Sheet	<b>1 of 2</b>
01	New cap			Scale	1:2
N°	REVIEW			Date	
Description				Material	
<b>Washbasin waste, free-flow</b>				Weight	
				0 kg	
Code	Date of issue	Chamfers not quoted		Finishing	
<b>P708-00</b>	23/04/2021	0.5x45°			 italian bathroomware
<small>This drawing is property reserved of Hotbath Srl. Without express authorization, the copying, distribution and utilization of this document as well as the communication to others is prohibited</small>

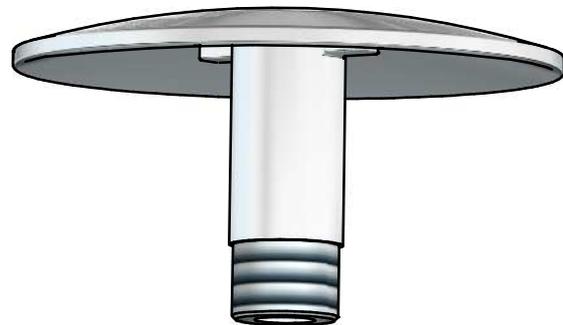
SCREWED PLASTIC INSERT  
ON CAP (THE USUAL OF THE NEW  
P710  $\phi$ 63).

OLD VERSION  
ONE PIECE IN BRASS  $\phi$ 72
